# DART SERVICE INSTRUCTION

TO AMEND INSTALLATION INSTRUCTIONS IIN-D412-702 REV. E AND  
INSTRUCTIONS FOR CONTINUED AIRWORTHINESS ICA-D412-702 REV. 3

THE PURPOSE OF THIS DSI IS TO CLARIFY THE INSTALLATION INSTRUCTIONS FOR THE D412-702-043A/-043B  
SHOULDER HARNESS KITS ON THE 214B/B1 MODEL AIRCRAFT.

A	NEW ISSUE	AJS	09.03.20
REV.	DESCRIPTION	BY	DATE
DESIGN	AJS	<b>DART AEROSPACE LTD</b> HAWKESBURY, ONTARIO, CANADA	
DRAWN	AJS		
CHECKED	<i>[Signature]</i>	DRAWING NO.	REV. A
MFG. APPR.	N/A	DSI 9453	SHEET 1 OF 1
APPROVED	<i>[Signature]</i>	TITLE	SCALE
DE APPR.	<i>[Signature]</i>	CLARIFICATION FOR 214B/B1 MODELS	NTS
DATE	09.03.20	COPYRIGHT © 2009 BY DART AEROSPACE LTD THIS DOCUMENT IS PRIVATE AND CONFIDENTIAL AND IS SUPPLIED ON THE EXPRESS CONDITION THAT IT IS NOT TO BE USED FOR ANY PURPOSE OR COPIED OR COMMUNICATED TO ANY OTHER PERSON WITHOUT WRITTEN PERMISSION FROM DART AEROSPACE LTD.

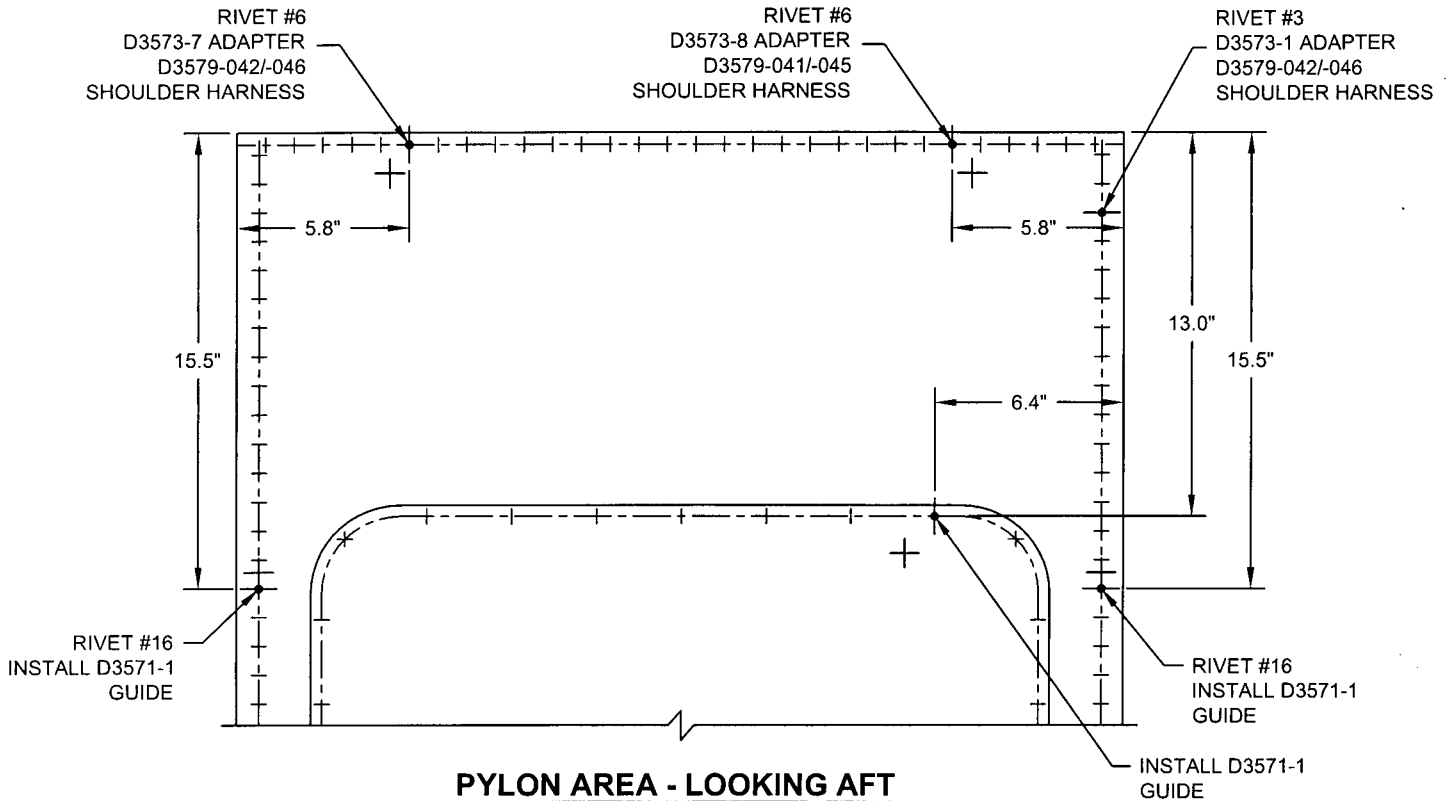
+ = INSTALL LOCATIONS PER IIN-D412-702 REV. E.

- = INSTALL LOCATIONS TO BE USED ON 214B/B1 MODEL AIRCRAFT.  
DRILL OUT/ REMOVE EXISTING FASTENER AT THESE LOCATIONS & OTHERWISE  
INSTALL D3573-X ADAPTERS OR D3571-1 GUIDE PER IIN-D412-702 REV. E.  
IT IS ACCEPTABLE TO USE MS21042L3 NUTS IN LIEU OF D3578-041 DOUBLERS
